**Draft Amendment No. 3**

**AIS-099**

**Approval of Vehicles with regards to the Protection of the Occupants in  
the event of a Lateral Collision**

**2. Paragraph 5.3.1., amend to read:**

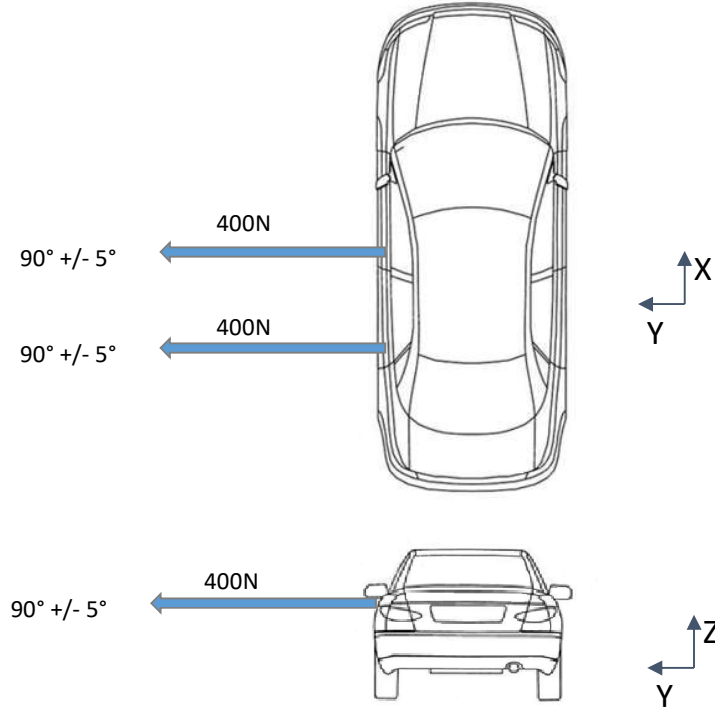
- 5.3.1. No door shall open during the test.  
This requirement is deemed to be fulfilled:
  - (a) If it is clearly visible, that the door lock is latched; or
  - (b) If the door does not open under a static tractive force of at least 400 N in the y-direction applied to the door, according to the Figure below, as close as possible to the window sill and to the edge of the door opposite to the hinged side, except to the door handle itself.
